DON'T SUFFER BAD BUFFERS!

Defective buffers for the M240B/M240L machine guns have gotten out in the field. The buffers, NSN 1005-01-461-0326, have bad hydraulic fluid fill plug screws that can loosen during firing. The buffer's hydraulic fluid then leaks out, which means the buffer can't do its job. That can lead to a ruined receiver.

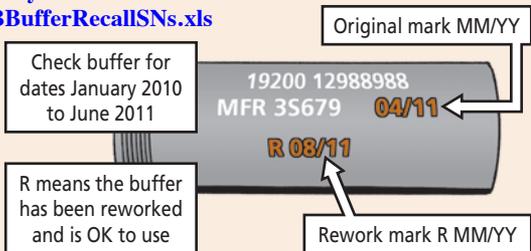
Armorer, if you have any M240B/M240Ls on the list have your small arms maintenance shop check for the bad buffers, which are stamped with an ID code date of January 2010 to June 2011.

They should disassemble the buttstock assembly and check if its buffer is within the date range. If the buffer has no date stamped on it or the date isn't January 2010 to June 2011, the buffer is good to go as long as it doesn't show signs of leakage. If the buffer is within those dates but has R stamped on it, it has been reworked and is also OK to use.

But if the buffer is in the date range and has no R, it must be replaced. Deployed units can have the buffer replaced at the nearest small arms repair facility.
